City of Sycamore
2022 Wastewater Treatment Plant Demo
Addendum #1

February 3, 2023

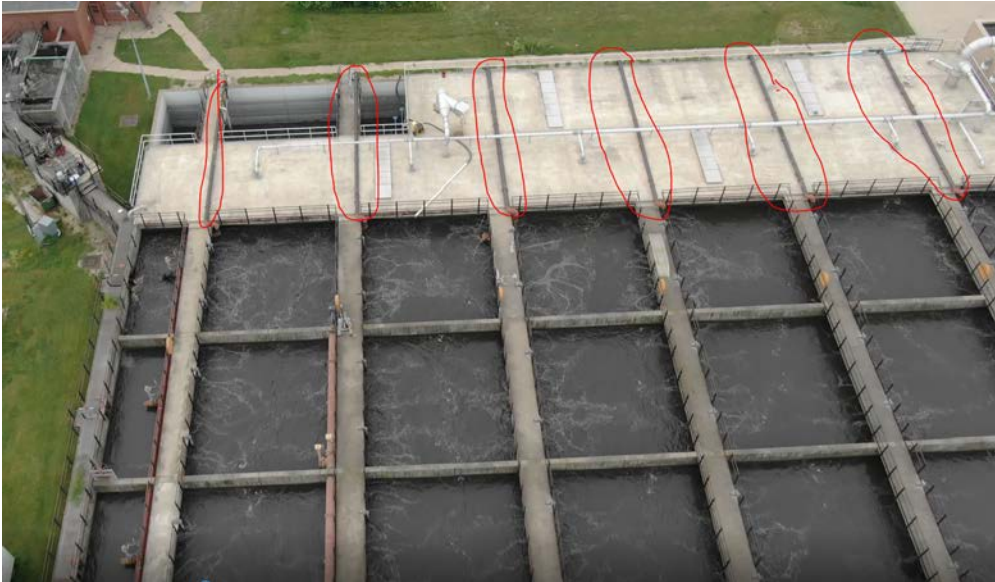
19. **Clarification:** Ductile piping on top of the aeration basins (area to remain) shall be removed. See photo below. (Facing South)
<https://www.youtube.com/watch?v=ouXiMCNQmuM> Appears at 1:26
